TECHNICAL SERVICE BULLETIN

10060

MODEL(S): 29 LTD with factory blue lighting

DESCRIPTION: How to adjust the BRT / DIM lamp intensity.

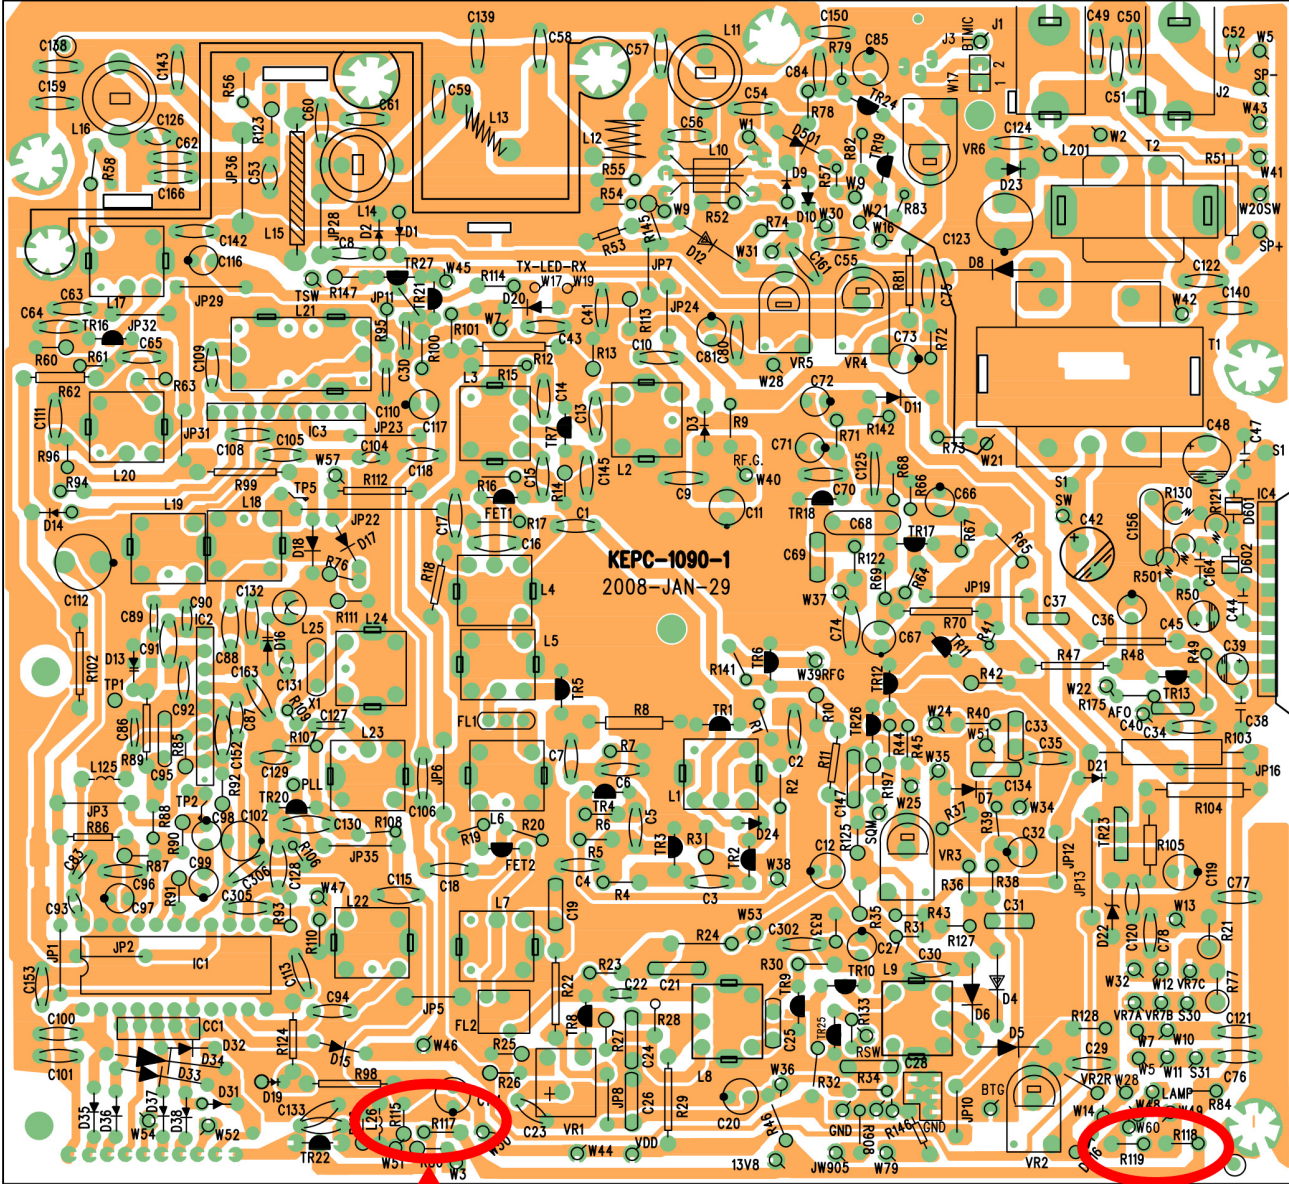
- BRT setting: change R118 (higher value = lower intensity)
- DIM setting: change R119 (higher value = lower intensity)

Changing the intensity of the channel display is a bit more difficult:

- To adjust both the BRT and DIM settings, change R117.
- If you want to adjust only the DIM setting, change R115.
- If you want to adjust only the BRT setting, change R117 and then check the DIM setting and adjust R115 as needed.

NOTES: If you lower the intensity of the channel display too much, some segments may appear brighter than others.
